Rear Engine Exhaust Cables

BULLETIN

Models Affected: Certain 2011 – 2017 Model Year Rear Engine All American Buses with a Selective Catalytic Reduction (SCR) and Diesel Particulate Filter (DPF).

SERVICE BULLETIN - S I 6 Y J

See Sheet 2 for illustration

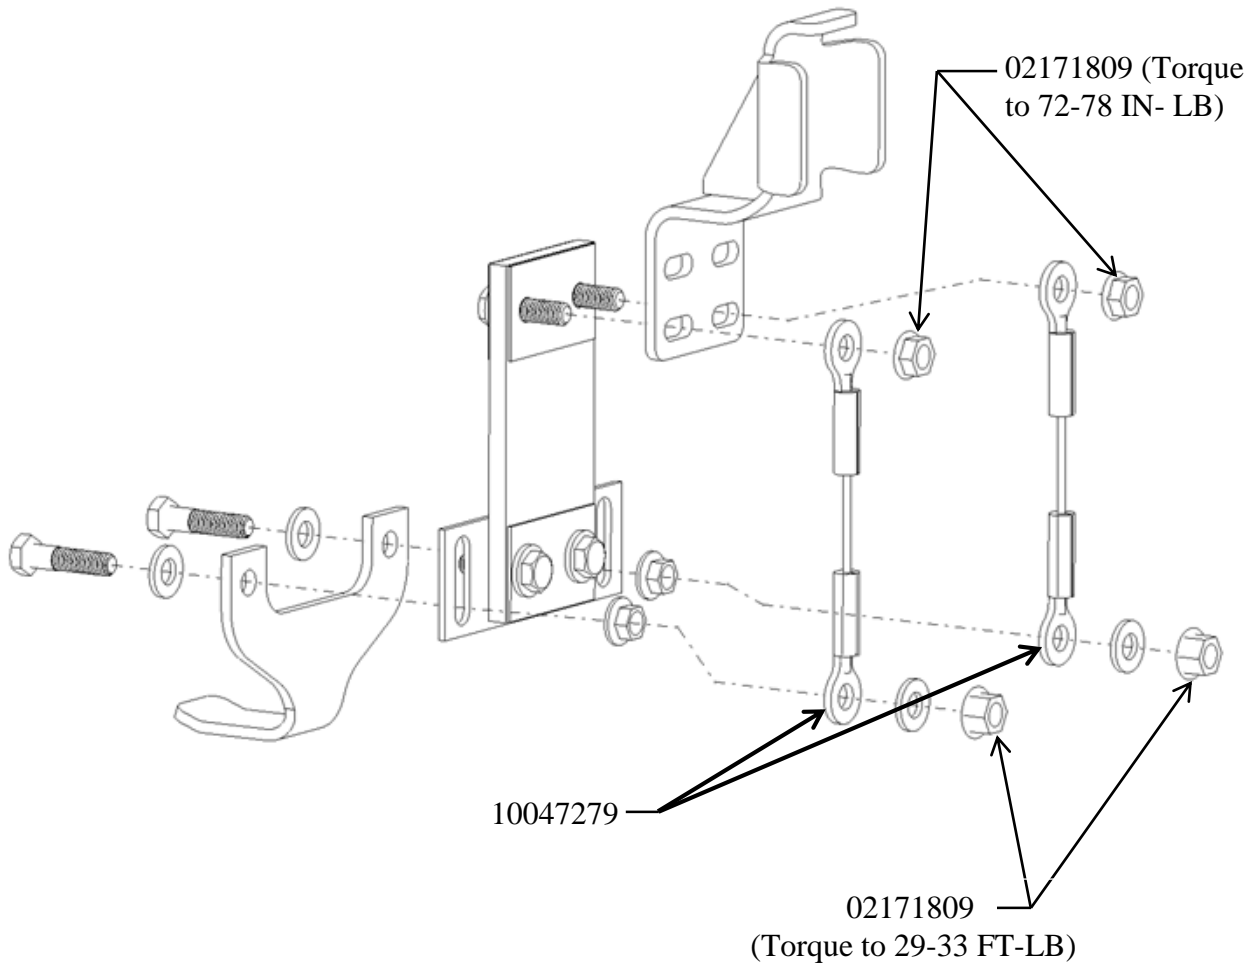
Rear engine exhaust support cables may fail.

Replace existing 5.5 inch cable assembly with new 6.0 inch cable assembly 10047279.

1. Park the bus on a level surface, apply parking brake, turn off engine, remove ignition key, and chock wheels.
2. Locate the four muffler hanger strap assemblies supporting the SCR and DPF at the rear of the bus.
3. Support the SCR and DPF, and replace the eight (8) 5.5 inch exhaust support cable assemblies with eight (8) 6.0 inch exhaust support cable assembly 10047279. Replace each cable assembly by removing the nut at the top of the cable assembly and the nut and washer at the bottom of the cable assembly. Discard old nuts, DO NOT reuse. Remove and discard the 5.5 inch cable assembly. Install the new 6.0 inch cable assembly and new nut at the top and new nut and washer at bottom.
4. Torque upper 3/8" nut to 72 – 78 in-lb. Torque lower 3/8" nut to 29 - 33 ft-lb.
